NOTICE OF DETERMINATION OF APPLICATION

Application No: DA2014/0024
Applicant: Greensill Bros Pty Ltd
Owner: Unwin Gaine Cartmill
Property Address: Boundary Creek Forest Road NYMBOIDA NSW 2460
Legal Description: Lot 20 DP 46031, Part Lot 48 DP 752839, & Part Lot 50 DP 752839
Development Proposal: Extractive industry hard rock quarry (Staged Development)

This addendum report to the original Environmental Impact Assessment (EIS) is to accompany an application to modify development consent DA2014/0024 under Section 96 of the Environmental Planning and Assessment Act 1979 (EP&A Act 1979).

- Amend Conditions 1, 9 and 29 to alter the staging of extraction rates of the quarry;
- Amend Condition 19 to provide for an alternate type of crossing at Copes Creek on Boundary Creek Forest Road;
- Relocation of the access to the Quarry from Boundary Creek Forest Road and associated adjustments to the quarry layout.

Figure 6.1 Stage 1 Overflow Frequency

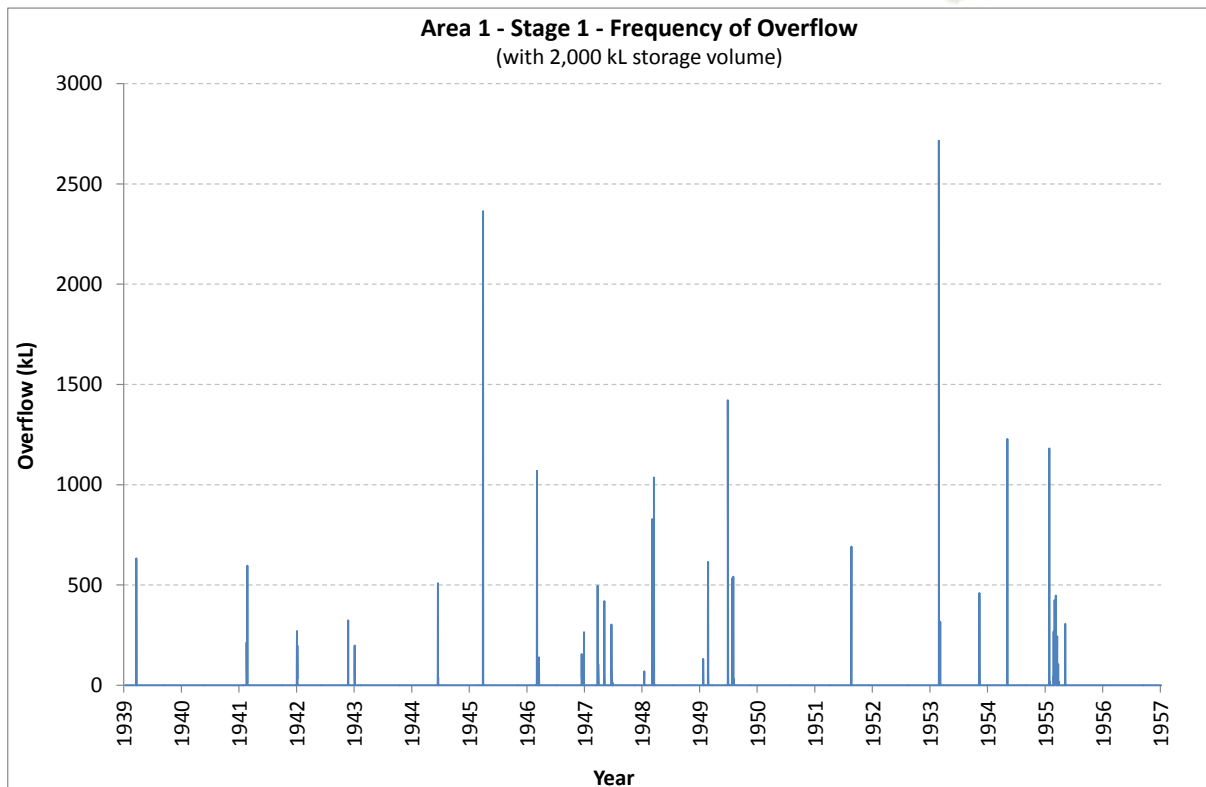
The site water balance for Stage 1 is presented in **Table 6.3** and a chart showing the frequency of uncontrolled overflows during the simulation period is presented in **Figure 6.1**. The average annual overflow frequency is one spill per year (rounded down from 1.4).

Figure 6.2 Stage 2 Overflow Frequency

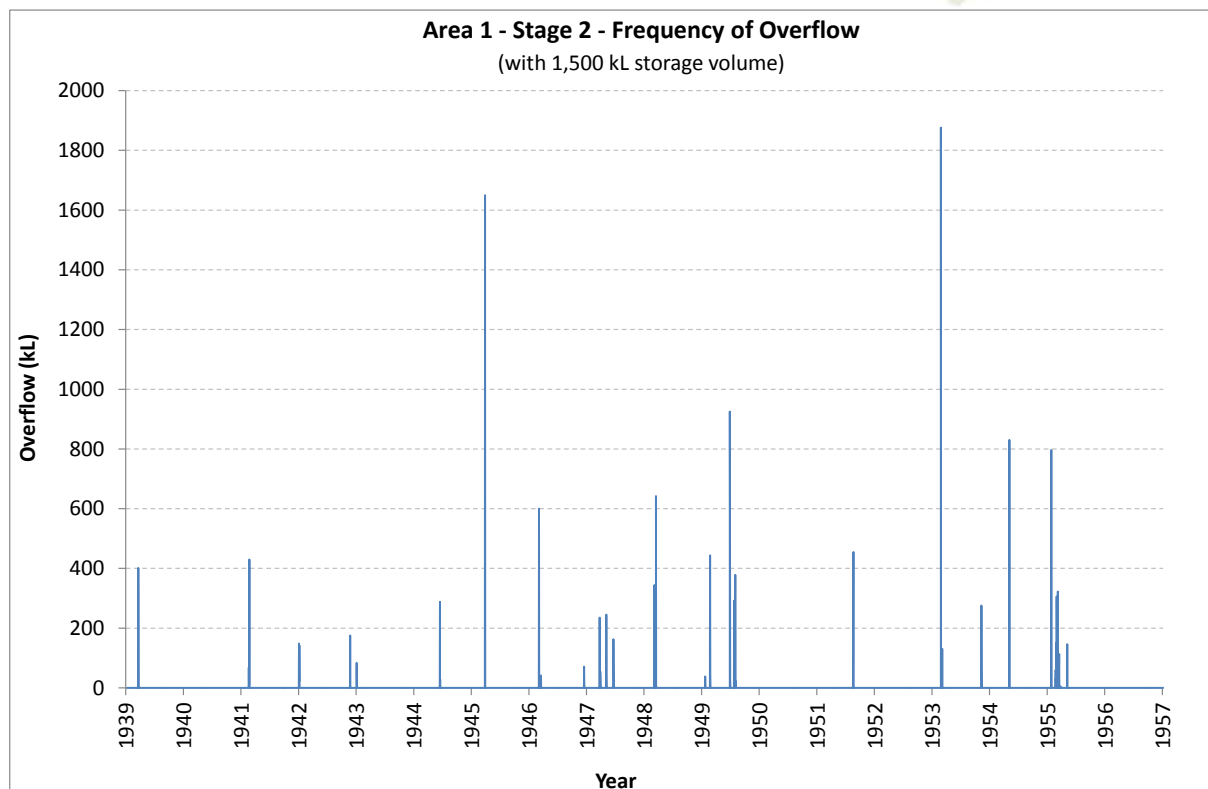
The site water balance for Stage 2 is presented in **Table 6.4** and a chart showing the frequency of uncontrolled overflows during the simulation period is presented in **Figure 6.2**. The average annual overflow frequency is one spill per year (rounded down from 1.5).

Figure 6.3 Stage 3 Overflow Frequency

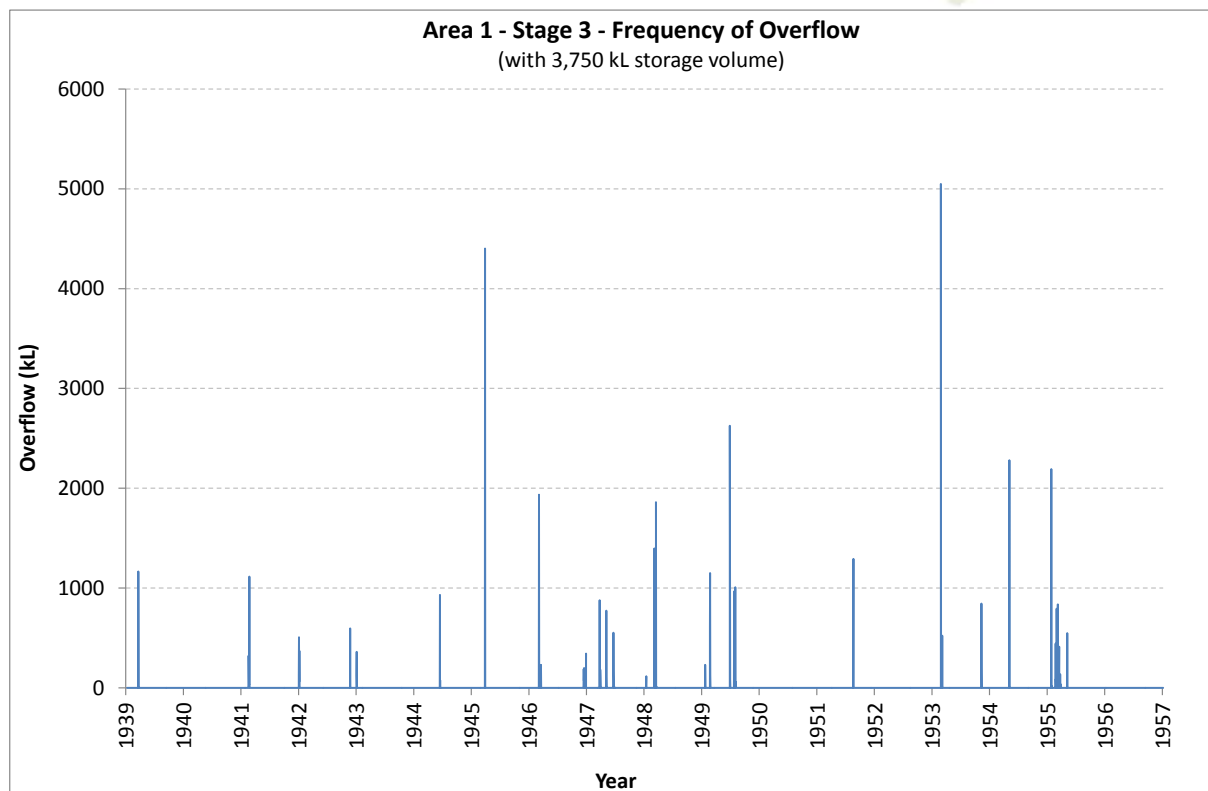
The site water balance for Stage 3 is presented in **Table 6.5** and a chart showing the frequency of uncontrolled overflows during the simulation period is presented in **Figure 6.3**. The average annual overflow frequency is one spill per year (rounded down from 1.4).

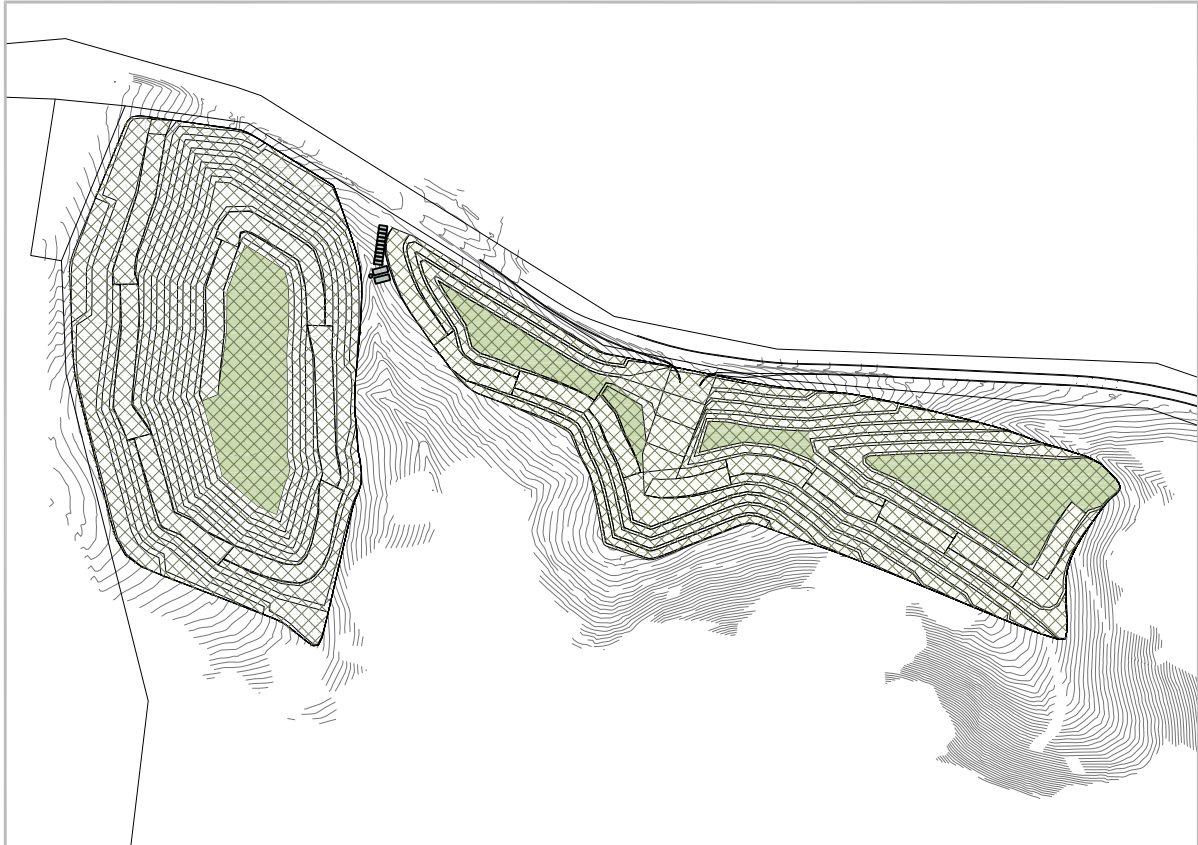
The adjustments to the quarry access and plan (refer **Section 2.5**) have necessitated amendments to the rehabilitation plan. This amended rehabilitation plan is shown in **Illustration 16.1**.

Boundary Creek Forest Road and
Quarry Access - Revised Intersection

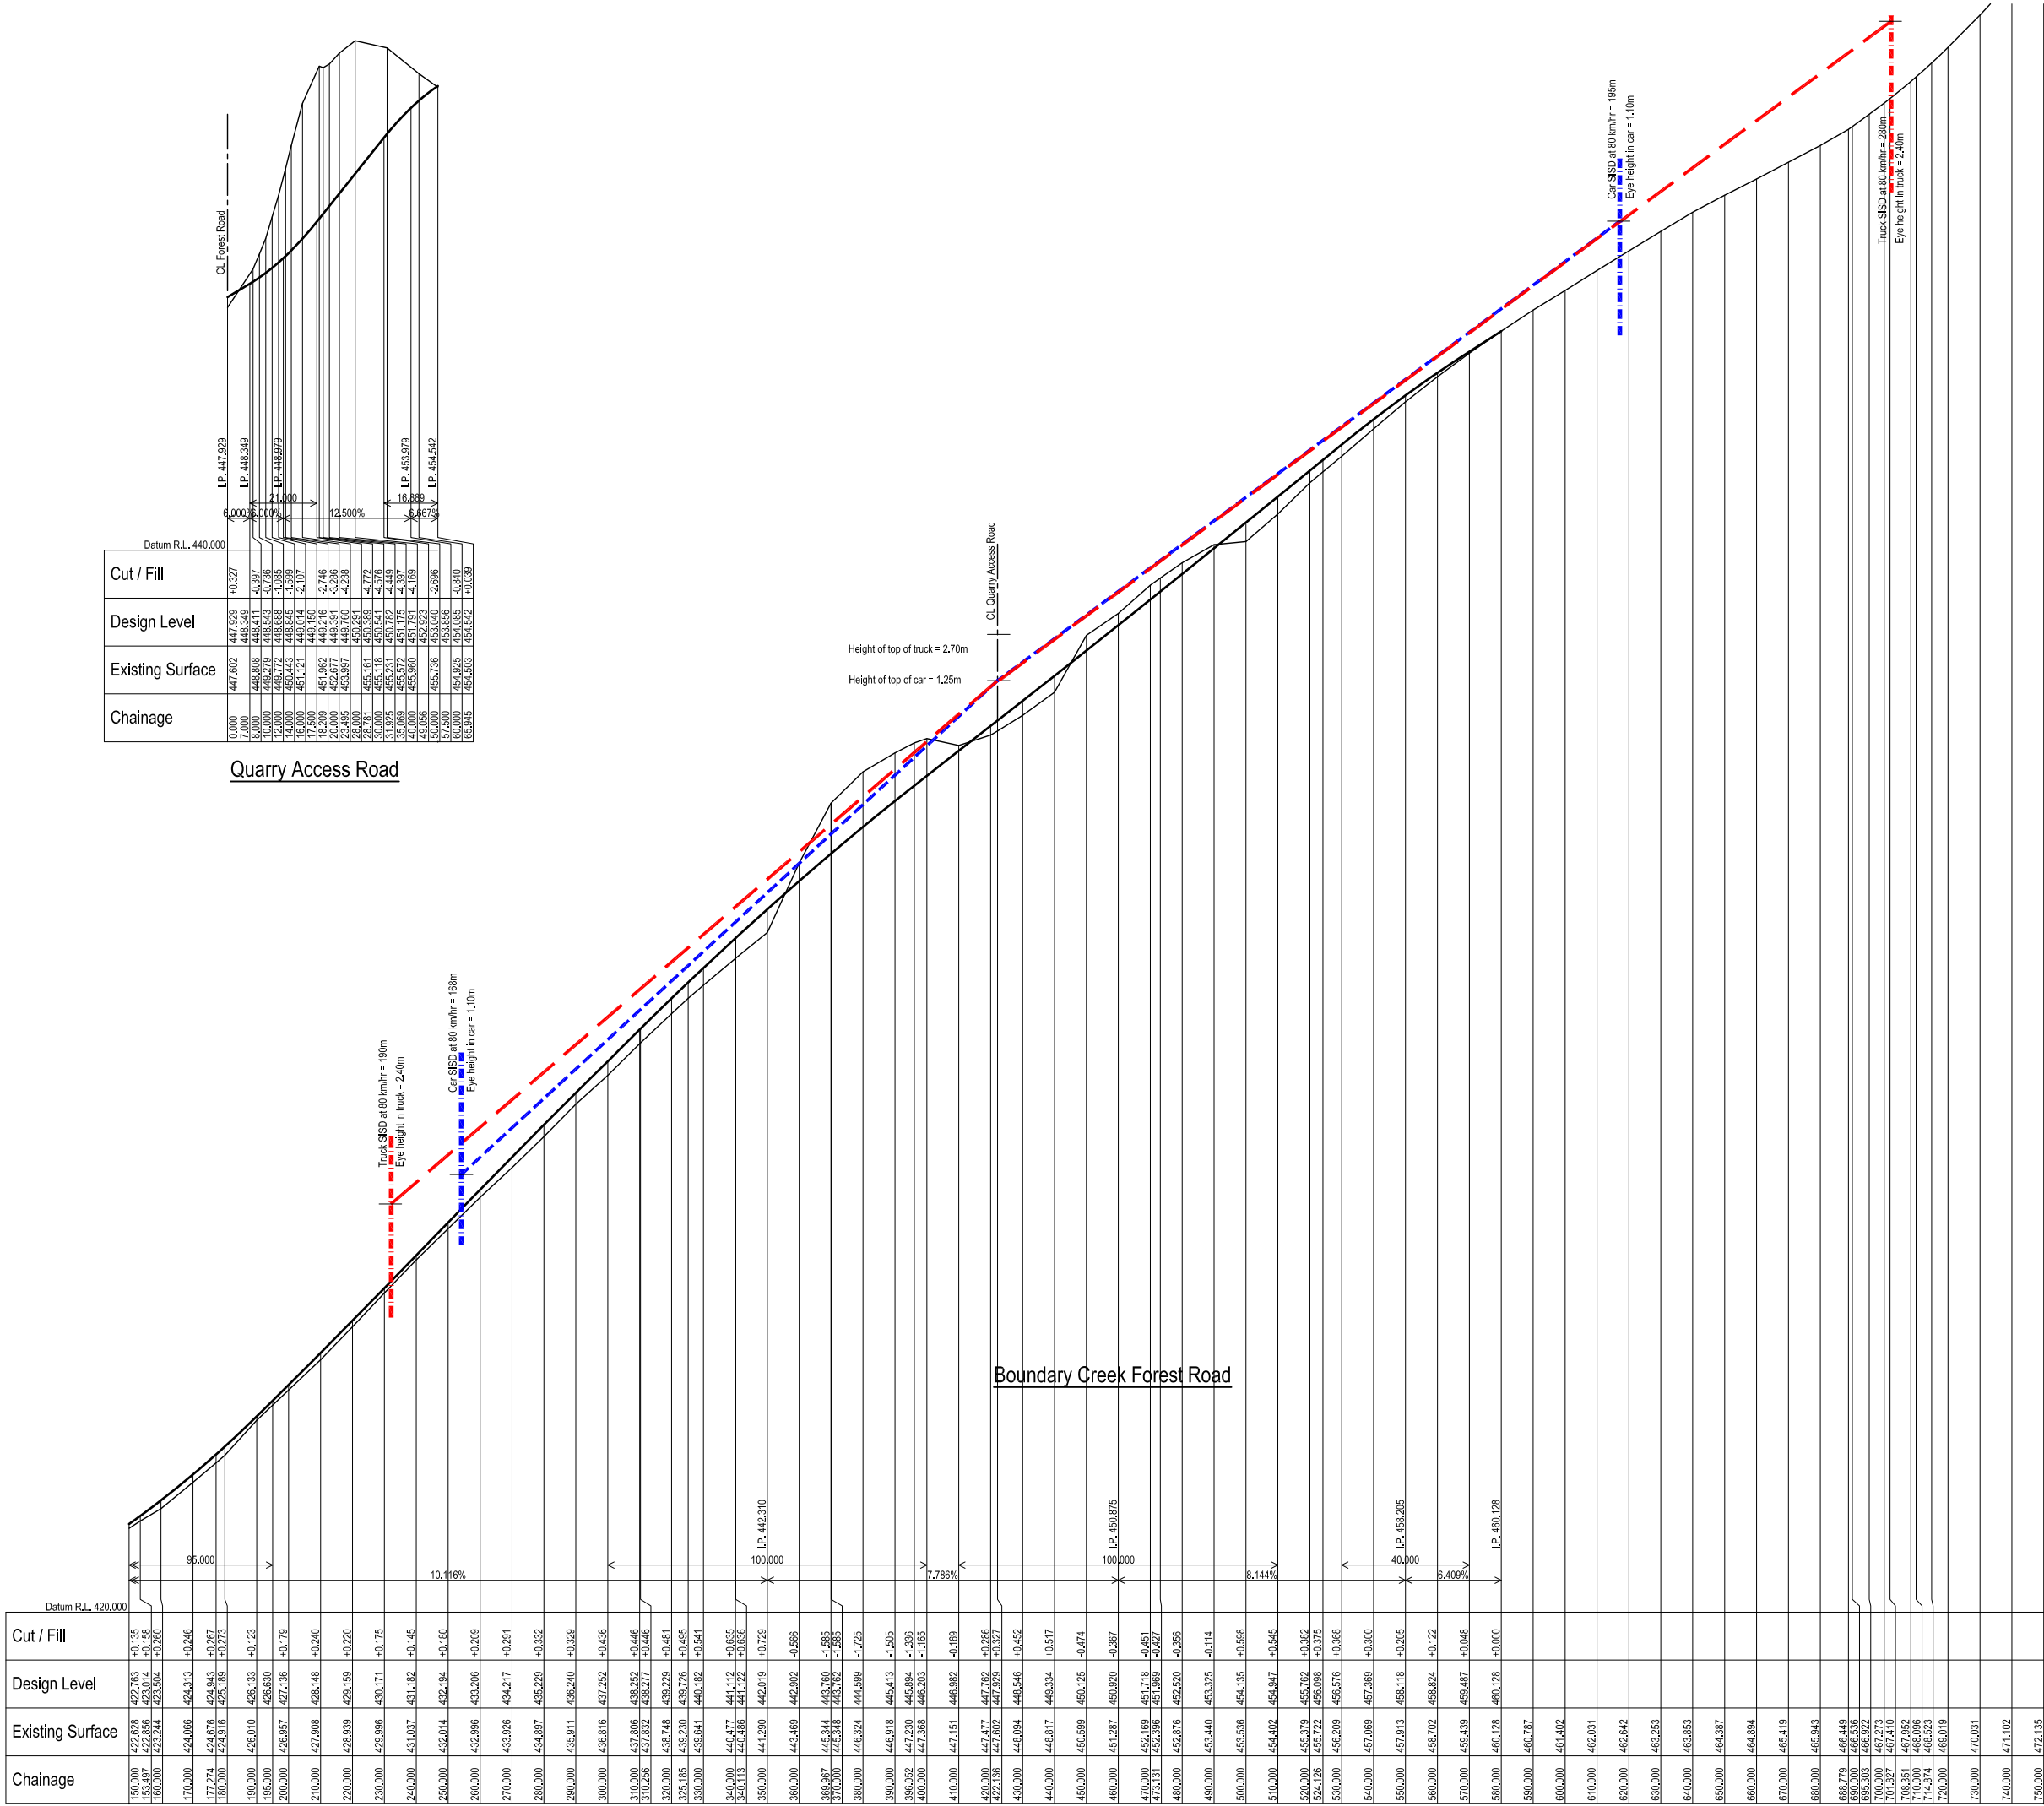
The proposed modification seeks to amend DA2014/0024 to change the location of the quarry access from Boundary Creek Forest Road. The new access will better service the operations of the quarry and will be considered a better location in terms of road safety. Further details including plans of the new access location are provided in **Section 2**. The new access location has also necessitated minor adjustments to the quarry layout and also to proposed stages 1 – 3. These adjustments are discussed in **Section 2.5**.

The proposed new access point has necessitated some minor adjustments to the quarry plan. These adjustments are shown in **Illustration 2.3** which has been updated as part of this Addendum EIS. The location and design of the new access is shown in **Appendix B1**. The overall quarry plan and footprint is shown in **Illustration 2.4**.
